ITB# 06-18
LIFT STATION 11 RECONSTRUCTION

DATE: May 8, 2018

RE: Bid No. 06-18 **ADDENDUM NO. 01**

REV. Δ	DATE: 5/4/2018	BY: A WISHART	DWN: A. WISHART	SCALE: AS SHOWN	SHEET 15 OF 15
			CKD: D. HALE	DATE: 3/21/2018	
			APP: D. WAINSCOTT	REF:	
			CAD FILE: LS 11 Reconstruction	ISSUED:	
					U.C. PROJECT NO. ITB #06-18

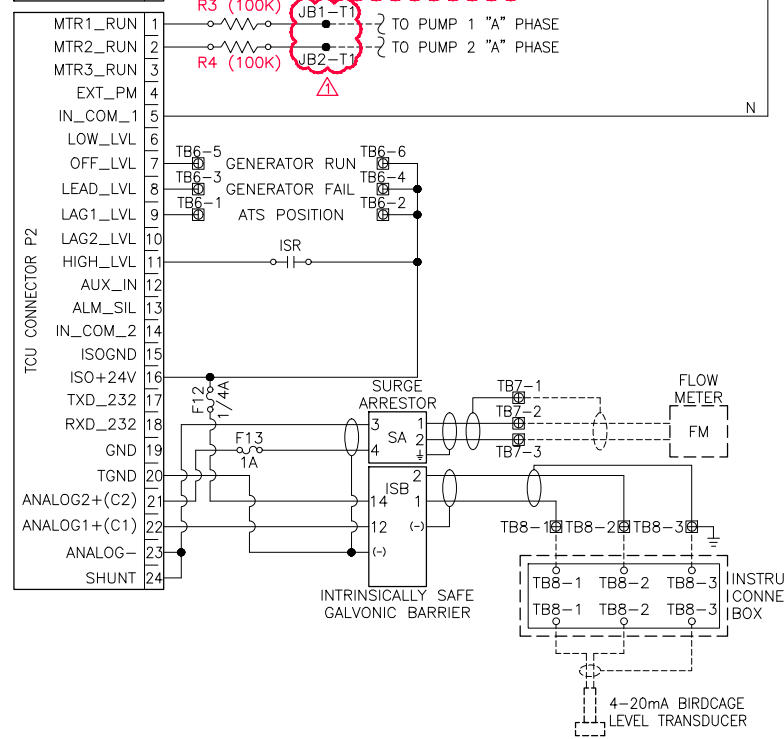
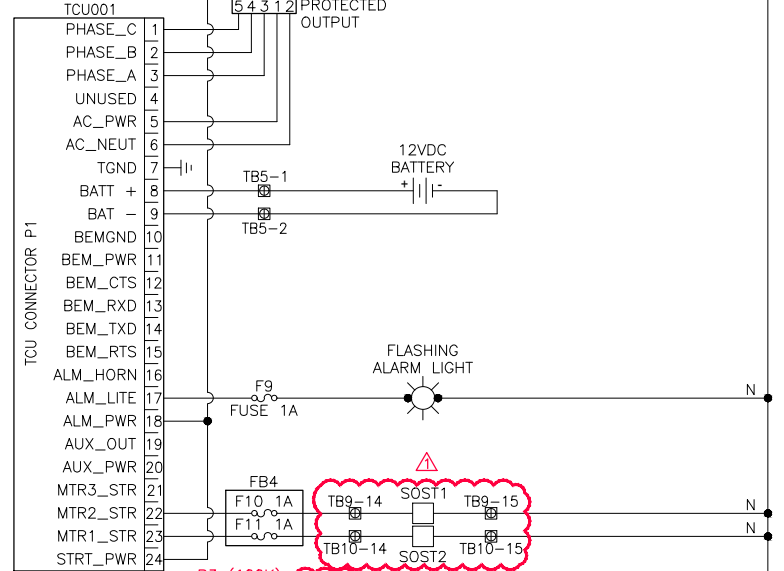
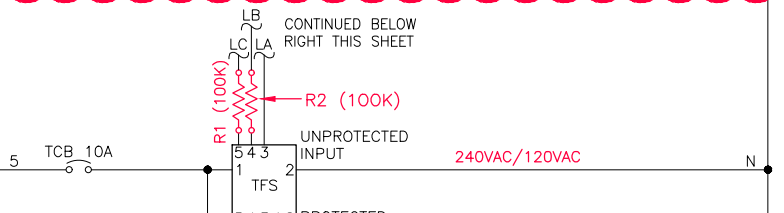
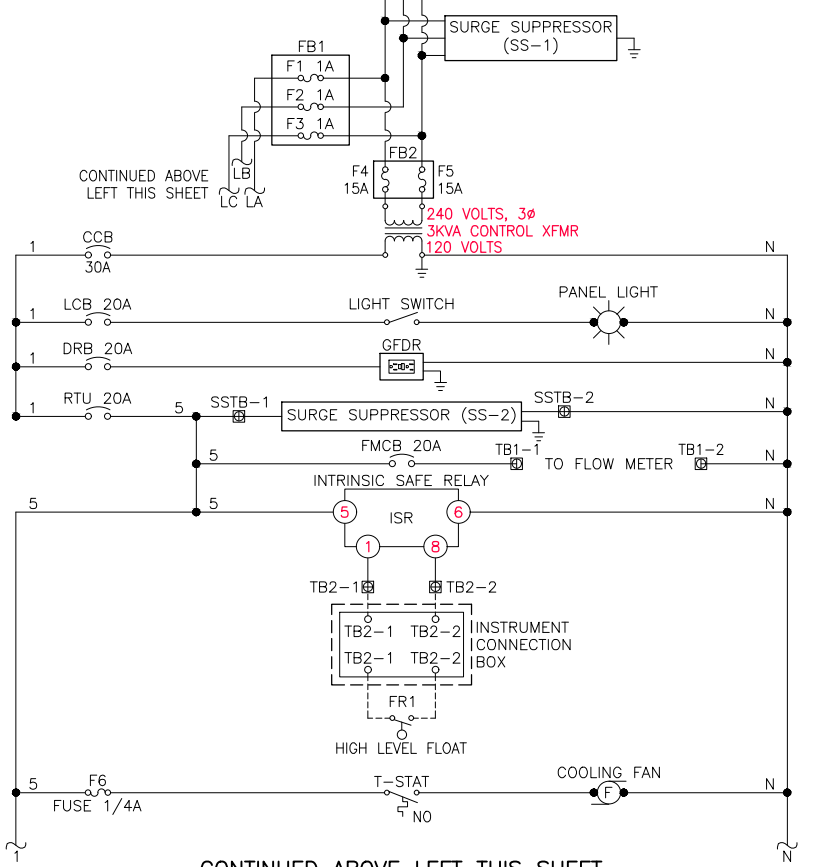
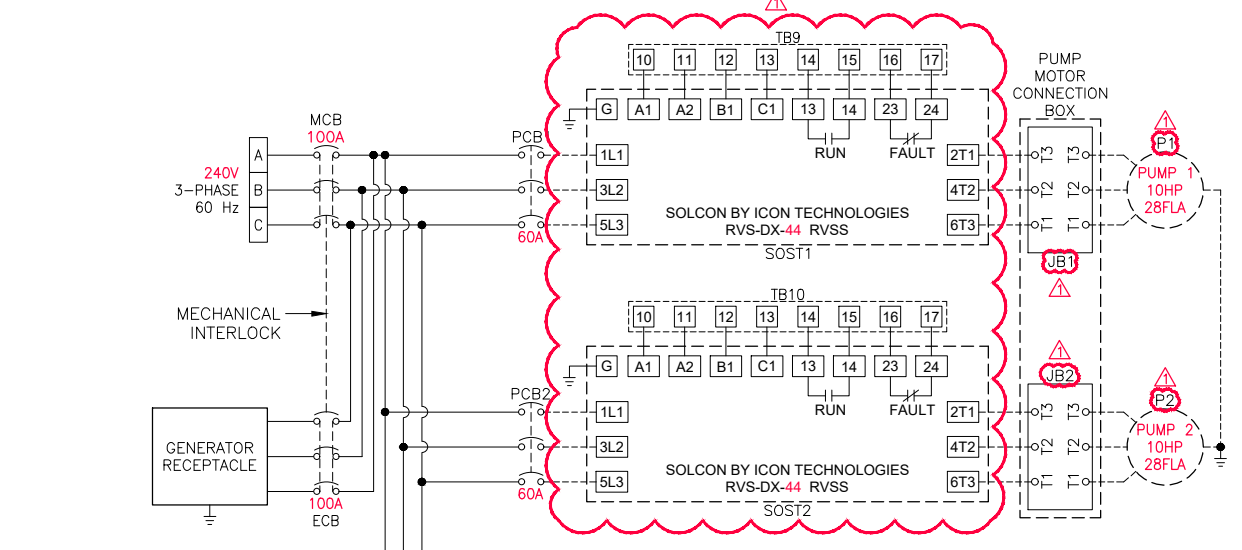
Drawing sheet 15 of 15: The bill of material does not list the soft start at all. Please confirm that Solcon model RVS-DX soft starts are required as shown on attached UCNSB standard lift station drawing sheet 2 of 2. * One correction to my 4/18/2018 RFI. Drawing sheet 15 of 15 lists "Baldor" as the Soft start. UCNSB has standardized on Solcon Model RVS-DX soft starts.*

Details related to electrical configuration of the Soft-Start panels are not provided. Please confirm that electrical configuration required is consistent with page 3 of the attached drawing.

The **COMMISSION** does not have a standard VFD or soft start. The **COMMISSION** approves Solcon model RVS-DX soft start and has revised the soft start detail for this project. See revised Lift Station Detail Sheets 12 and 15 attached. The **COMMISSION** will not change the standard VFD or soft start details at this time. Only Lift Station 11 soft start detail has been changed.

1		POLYPHASE COAXIAL SURGE PROTECTION KIT	DFS, DFS-00392-008-01
1		BATTERY BACKUP	DFS, DFS-00363-008-02
1		46" RF PIGTAIL	DFS, DFS-00125-008-12
1	SS1	000V SURGE SUPPRESSOR	DITEK, DTK-
1	SS2	120V SURGE SUPPRESSOR (DFS MODEL SPS001)	DITEK, DTK-120HW
1	ISR	INTRINSICALLY SAFE RELAY	ATC DIVERSIFIED, ISO-120-AFA
1	SA	SURGE ARRESTOR	PHOENIX CONTACT, TT-2-PE-24DC, 2838186
1		END COVER FOR SURGE ARRESTOR	PHOENIX CONTACT, 2838995
1	ISB	INTRINSICALLY SAFE BARRIER	DWYER INSTRUMENTS, MTL5041
2		PUMP SPlicer TERMINAL BLOCK	BUSSMANN, 16204-3
1	40	TERMINAL BLOCK	SQUARE D, 9080GR6
1		FOLDING LAPTOP SHELF, 18"	SCHAEFER'S ELECTRICAL ENCLOSURES, SP-SHELF18
1	GEN REC	GENERATOR RECEPTACLE	RUSSELLSTOLL, JRSB1044FR
1	FLOAT	ROTO-FLOAT SWITCH	ANCHOR SCIENTIFIC, S30NO
1	BCT	BIRDCAGE* LEVEL TRANSDUCER	BLUE RIBBON CORP., BC001
2	SOST1,2	SOFT STARTER	SOLCON, RVS-DX-44
0	FM	FLOW METER, ULTRASONIC	CLARK SONIC*, CSLFC

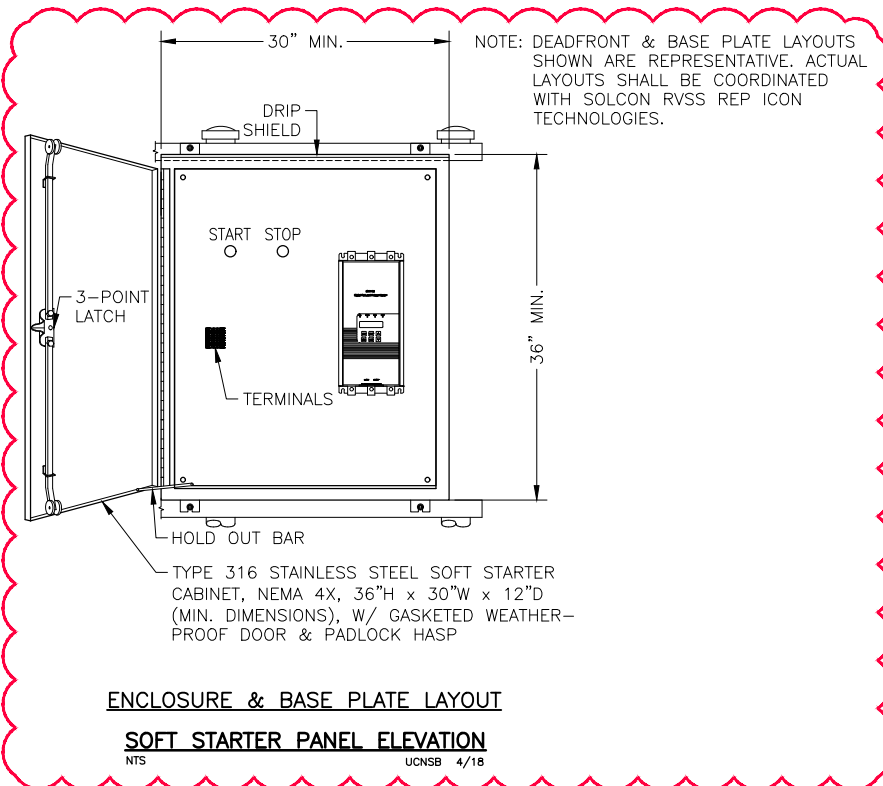
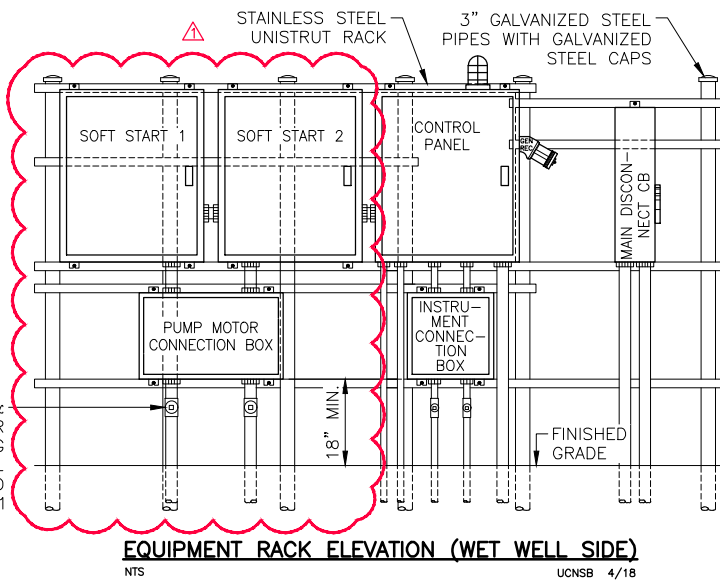
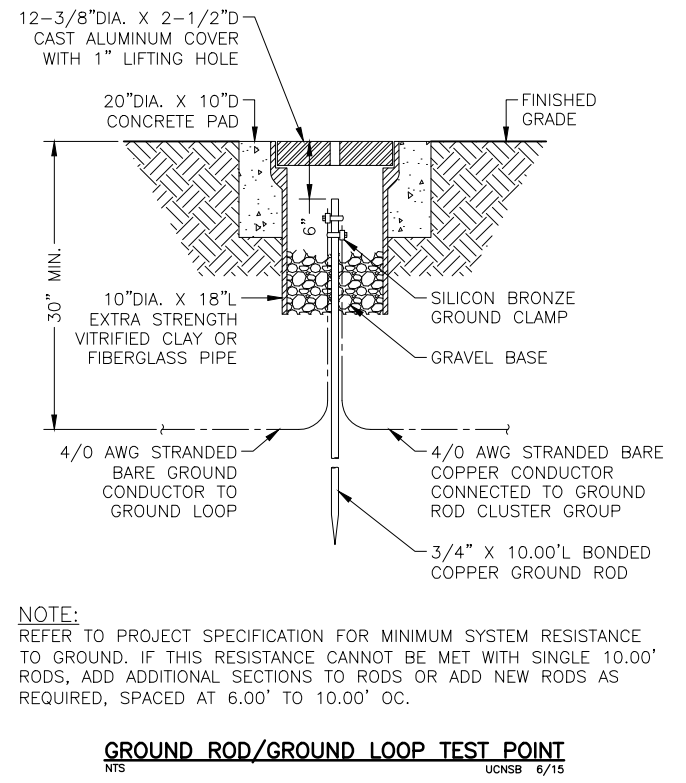
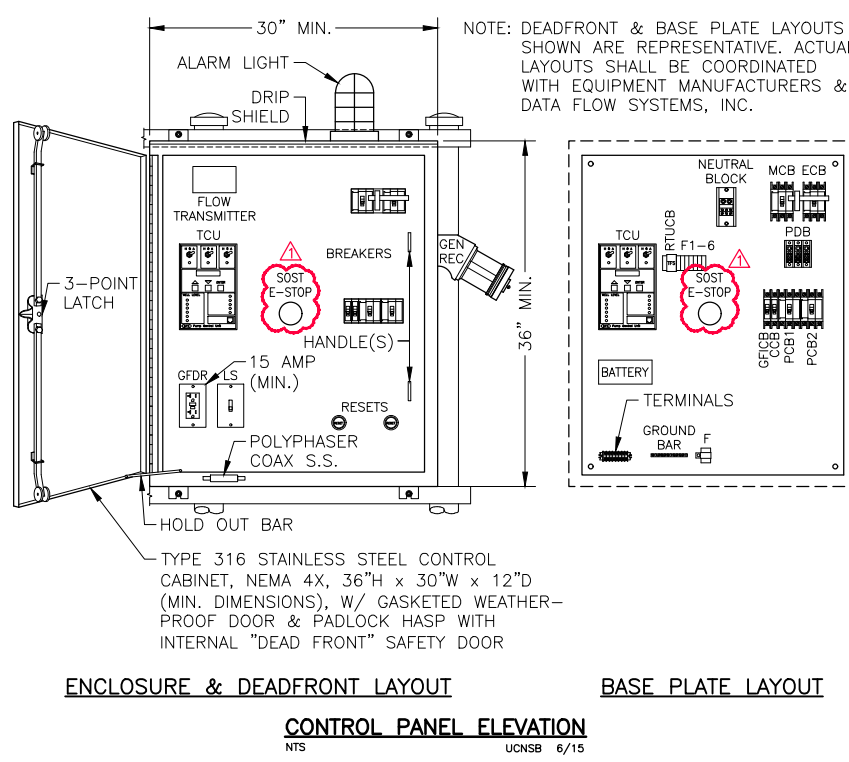
- The Estimated Bid Quantity for Bid Item No. 9 has been revised to “2 EACH” on the Bid Tabulation. The revised Bid Tabulation, Page 34, has been attached. The revisions are depicted in red.
- Lift Station Detail Sheets 12 and 15 have been revised and attached to this Addendum.
